PRODUCT CHANGE NOTIFICATION

Select Bourns® Surge Protective Devices

Changes to Inner Packaging

SPD2443

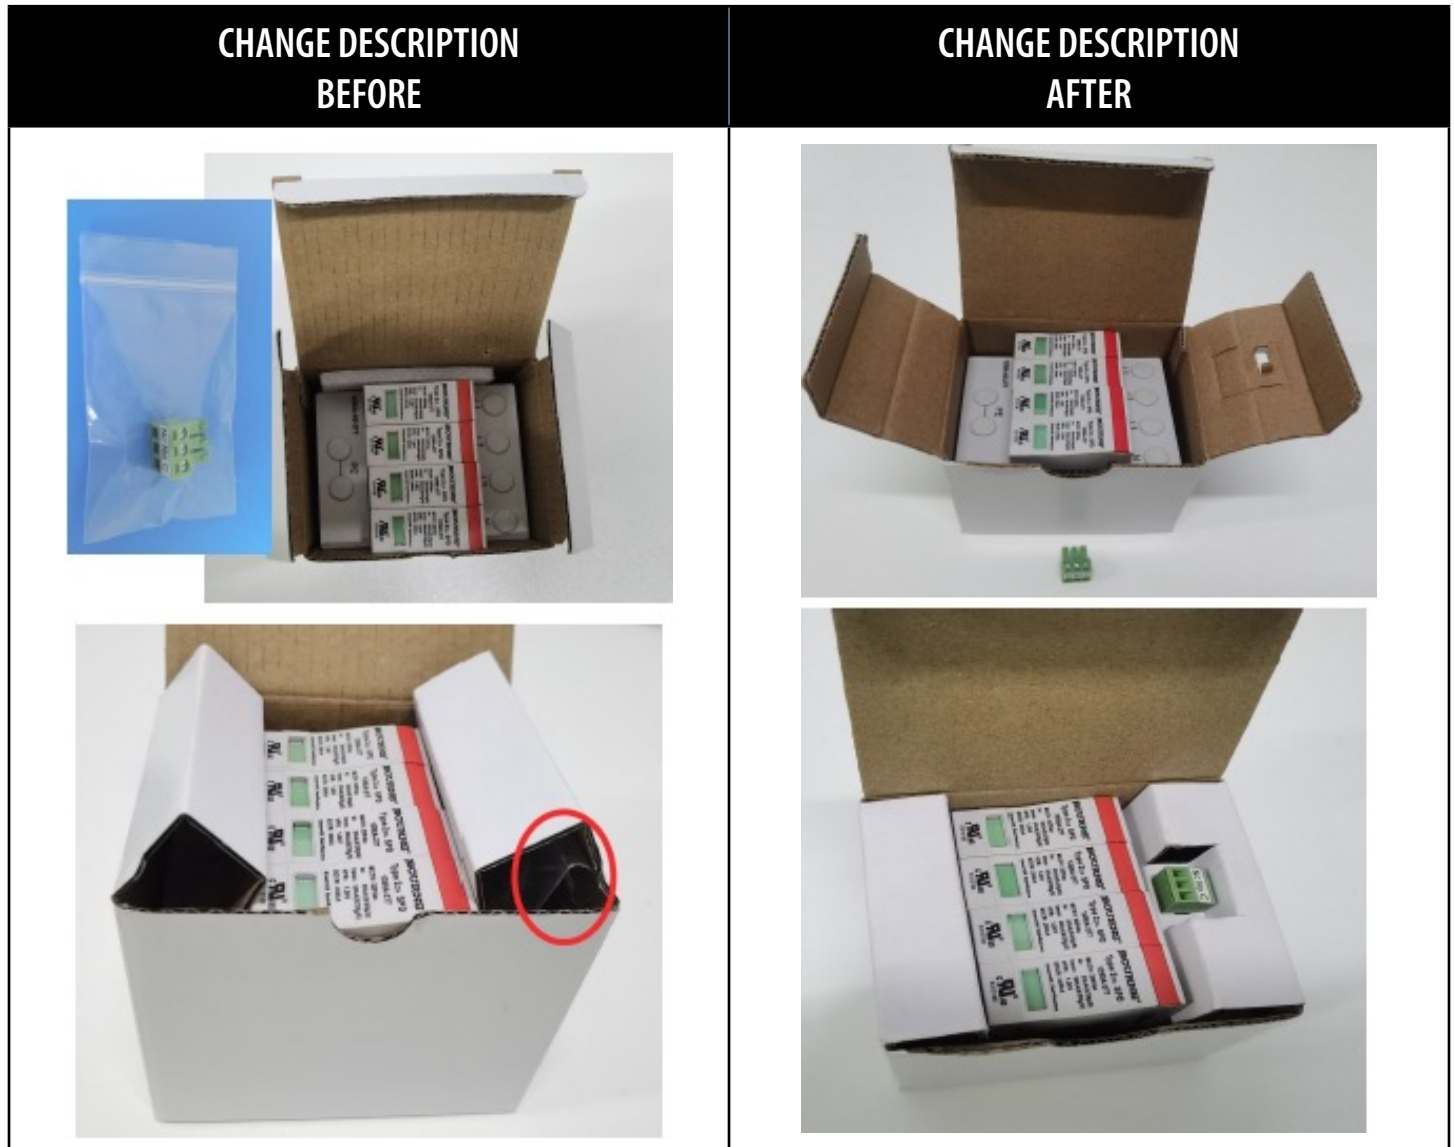
To meet the EU Plastic Tax Regulation, we will eliminate the plastic bag which is used to hold the remote signal terminal of the SPD. Consequently, we will change the inner packaging structure with a notch to fit and protect the remote signal terminal. The packaging size will be changed accordingly.

The change to the inner packaging will have no effect on the form, fit, function, quality, or reliability of the affected part numbers as this is a packaging change only. The product specifications will not change.
